City of Dublin

Memo

To: Members of Dublin City Council
From: Dana L. McDaniel, City Manager
Date: February 4, 2020
Initiated Jennifer M. Rauch, AICP, Interim Planning Director
By: Claudia D. Husak, AICP, Senior Planner
Chase J. Ridge, AICP Candidate, Planner I
Re: Ordinance 07-20
Rezoning with Preliminary Development Plan of +/- 24 acres from PUD, Planned Unit Development District (Tartan Ridge, Subareas D1, E and F) to PUD, Planned Unit Development District (Tartan Ridge, Subarea F) for the future development of up to 56 single-family homes and 7.9 acres of open space. The site is north of McKitrick Road and east of Hyland-Croy Road (Case 19-084Z/PDP)

19-084Z-PDP
Preliminary Development Plan/PUD Rezoning
The Overlook at Tartan Ridge

Exhibit 'B'

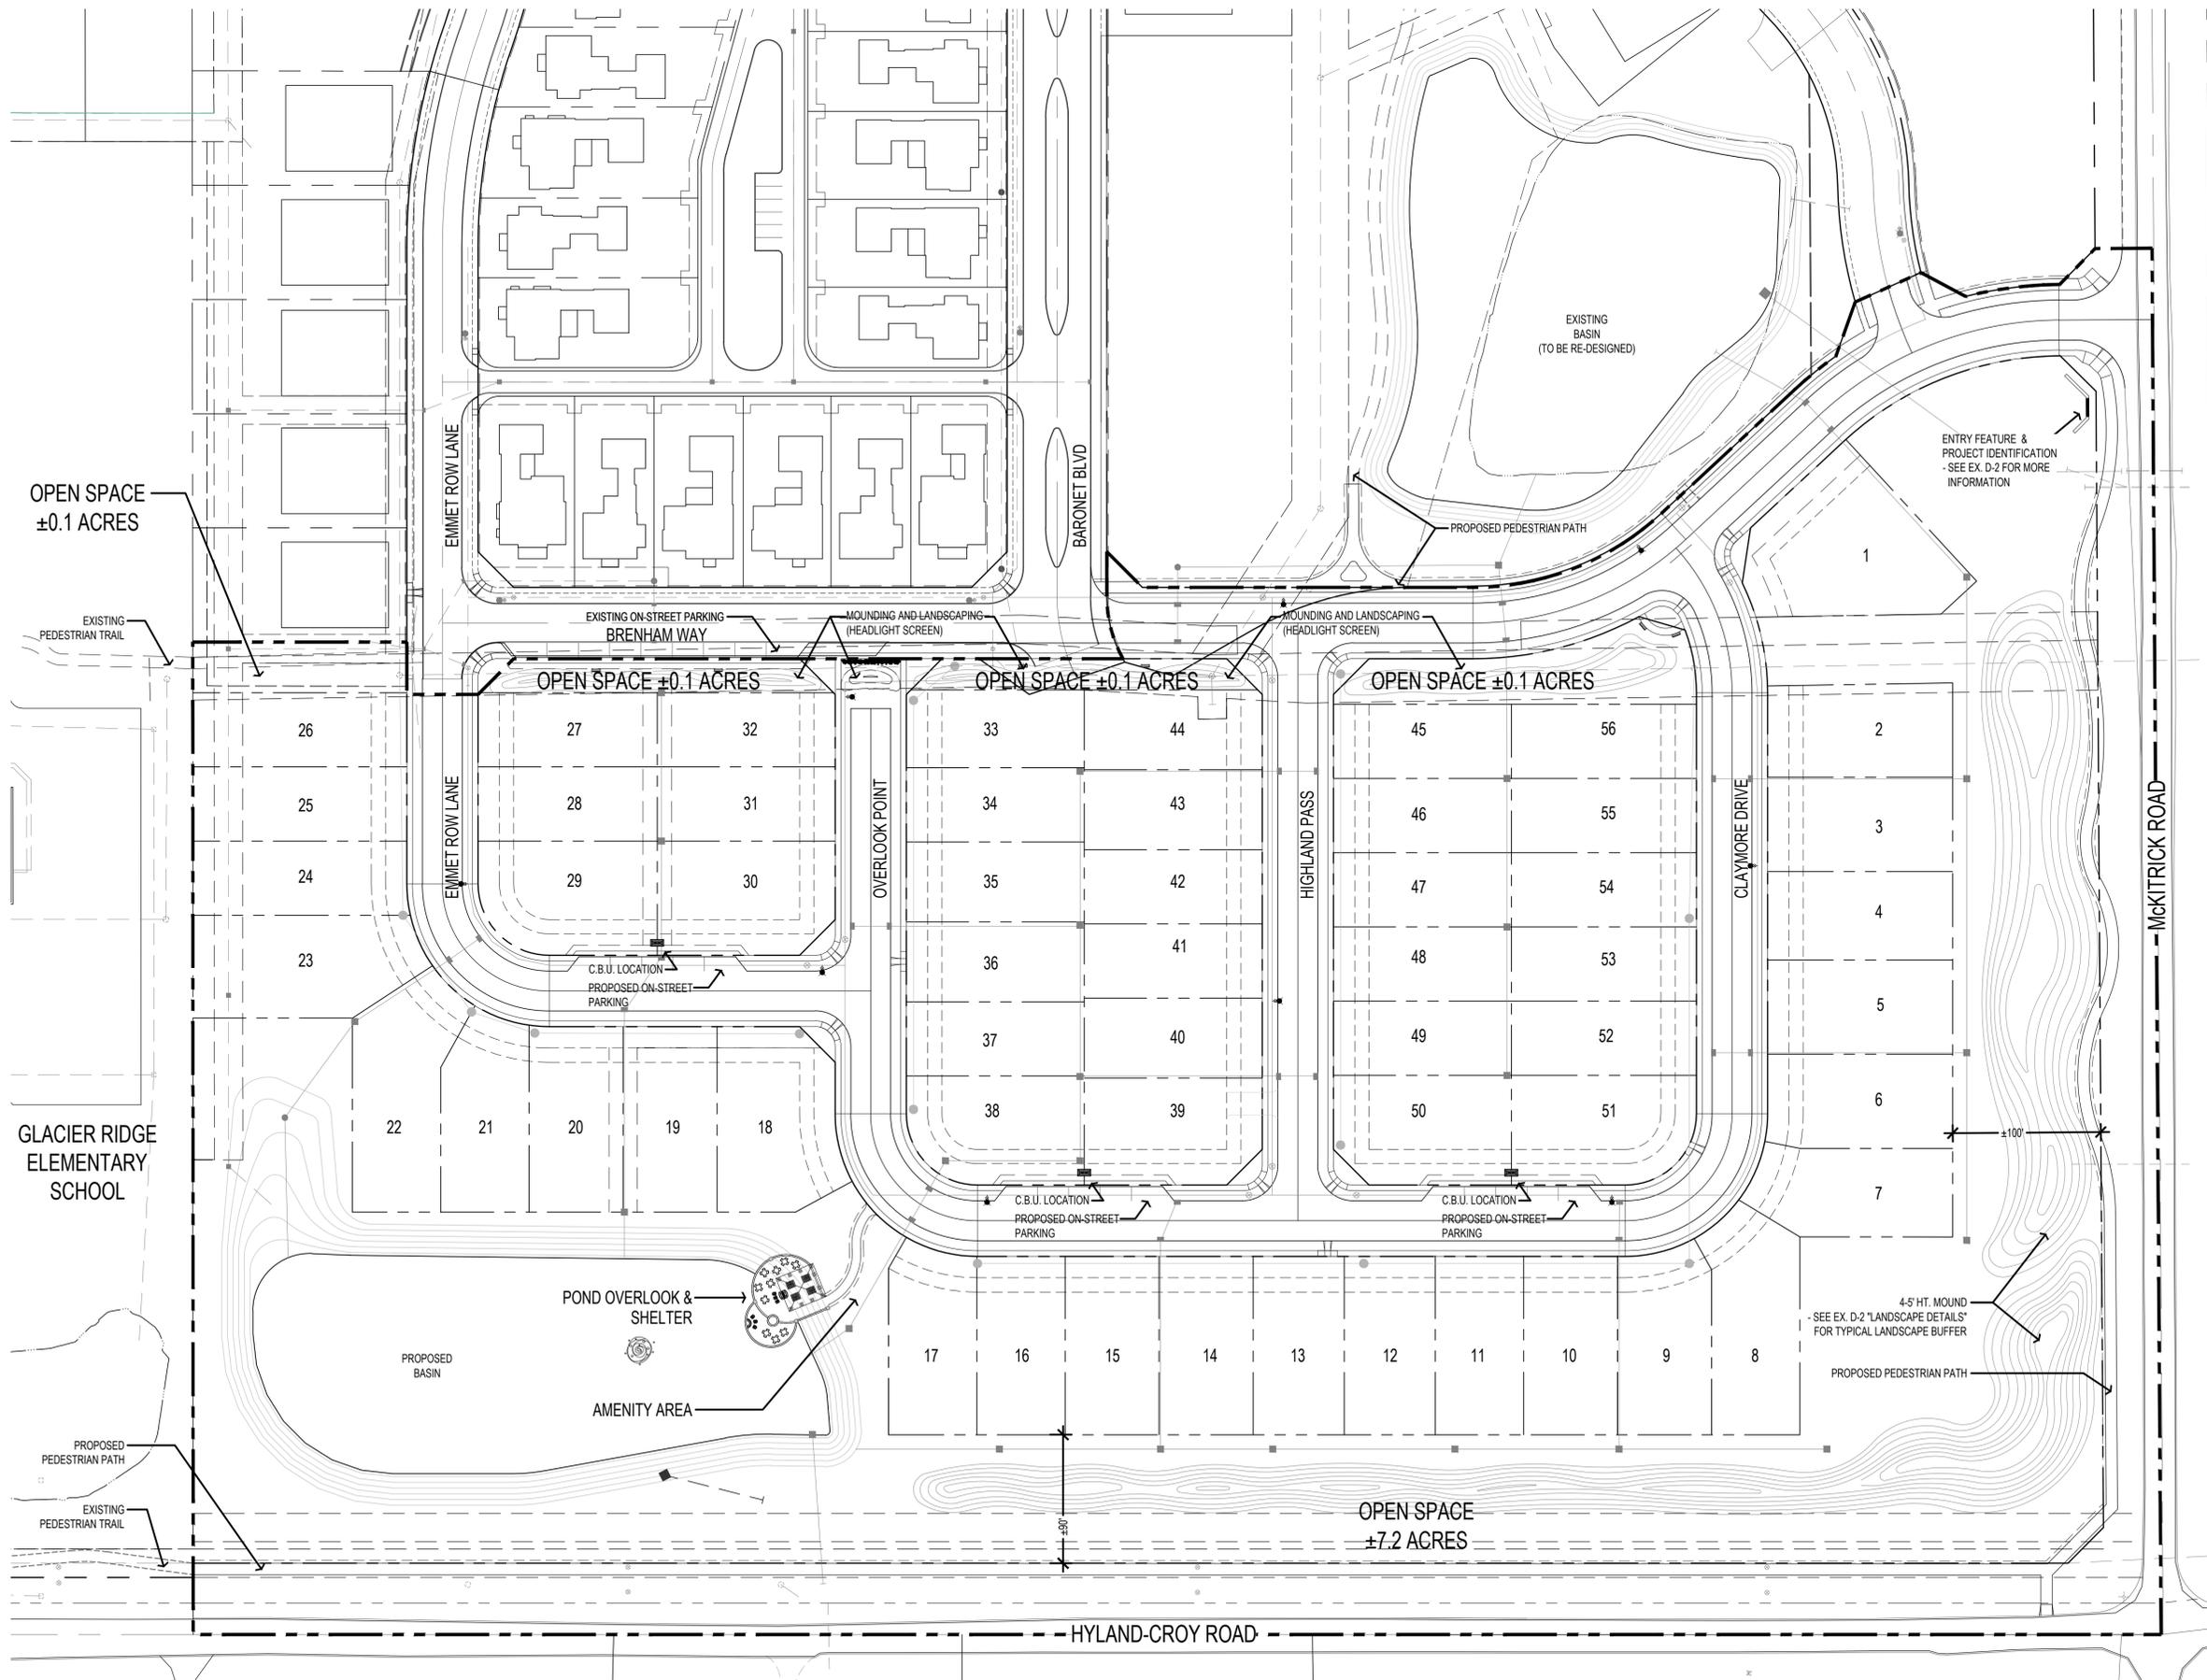
- 1) That the preliminary development plan Subarea map be revised to include the existing storm water management pond in the southeast portion of the site that is to be redesigned, prior to Council review;
- 2) That the applicant continue to work with Staff to ensure that the street names and naming method is appropriate;
- 3) That the applicant work with Staff to clarify HOA membership;
- 4) That the applicant remove the dry basin, add green space in the area and landscape material in the area, subject to Staff approval;
- 5) That the applicant provide opaque landscaping on the mound along Hyland Croy Road

The Planning and Zoning Commission recommended approval of the Rezoning with Preliminary Development Plan to City Council on December 12, 2019 with the conditions listed below. The applicant has addressed Conditions 1 and 2 on the plans submitted to Council. The dry basin has been removed from the proposal and green space has been added, landscape materials will be detailed at the Final Development Plan stage. Condition 5 will be addressed at the FDP as well. The development text has been updated, after consultations with Staff and the Tartan Ridge HOA leadership, to indicate that The Overlook at Tartan Ridge will join the Master Home Owners Association for Tartan Ridge while also creating a subsidiary HOA that will be responsible for on-lot maintenance (including the hedges) and the open space amenities related to The Overlook. All other conditions will be addressed at the final development plan stage.

Exhibit 'C-1'

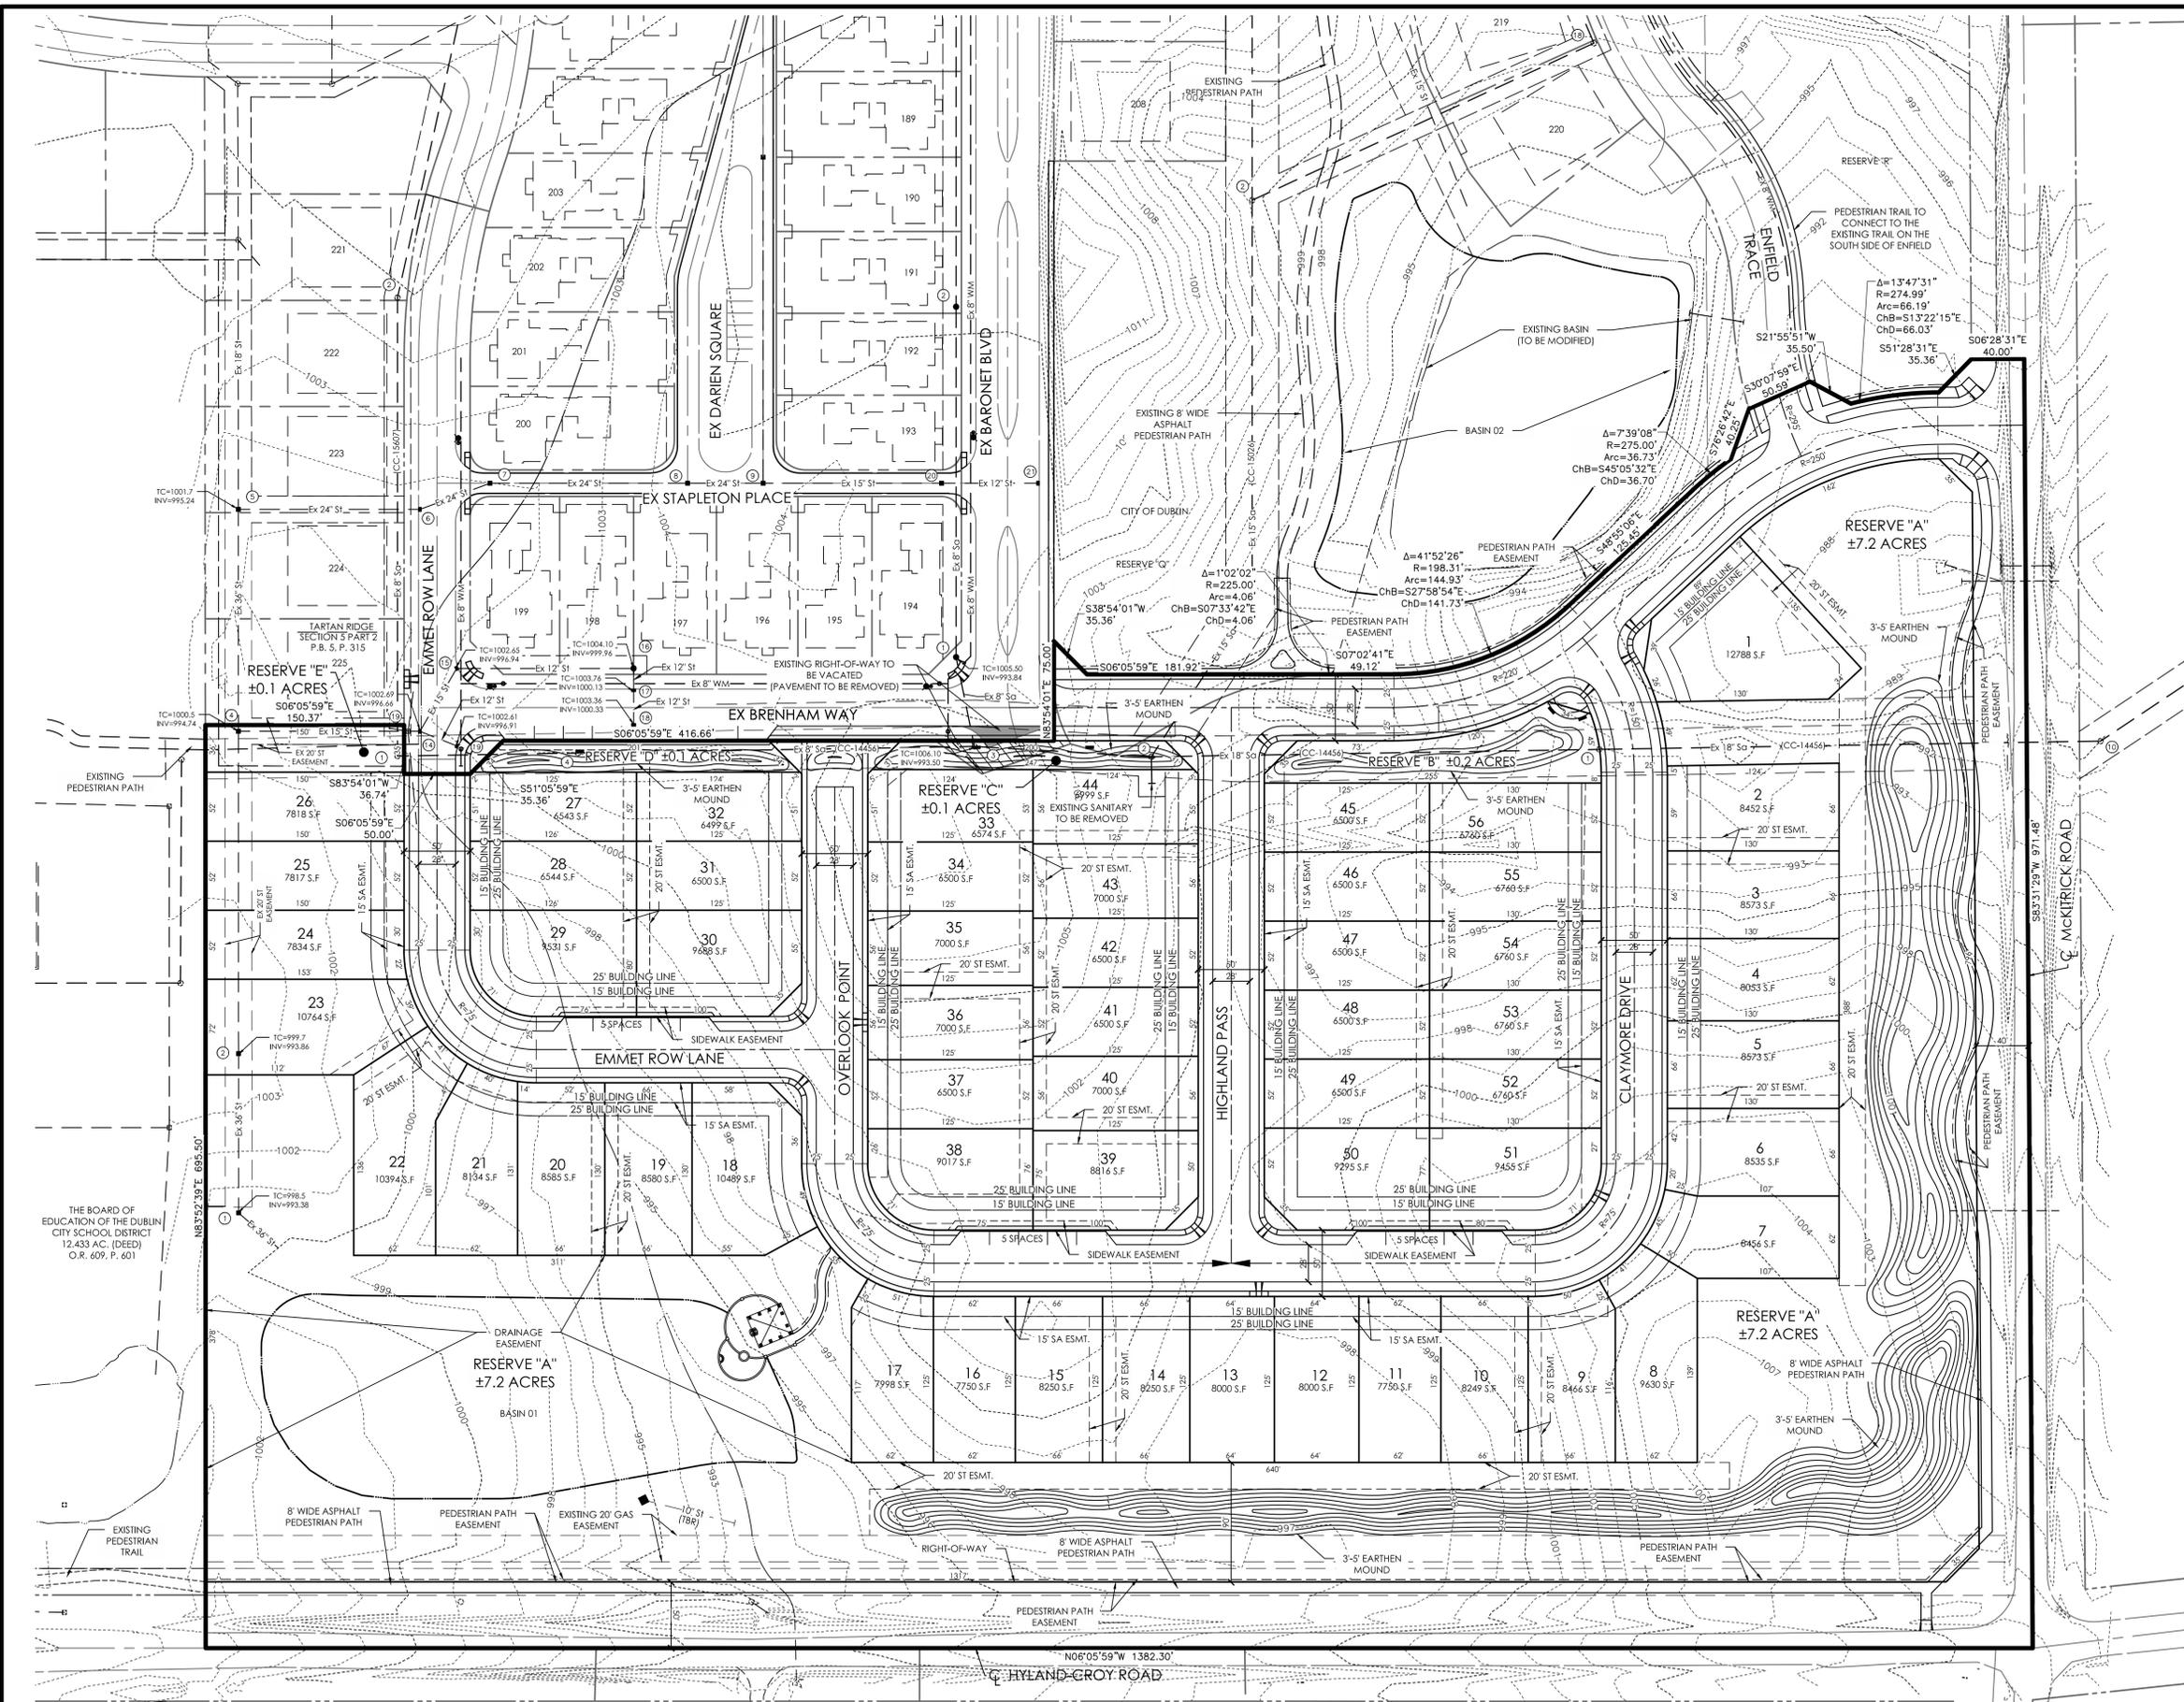
Ms. Newell referred to Exhibit C-1, which is an EMH&T plan. Running along Hyland-Croy Road, there are a number of dashed lines; what do they denote?

Ms. Newell referred to Exhibit C-1, which is an EMH&T plan. Running along Hyland-Croy Road, there are a number of dashed lines; what do they denote?

Ms. Newell referred to Exhibit C-1, which is an EMH&T plan. Running along Hyland-Croy Road, there are a number of dashed lines; what do they denote?
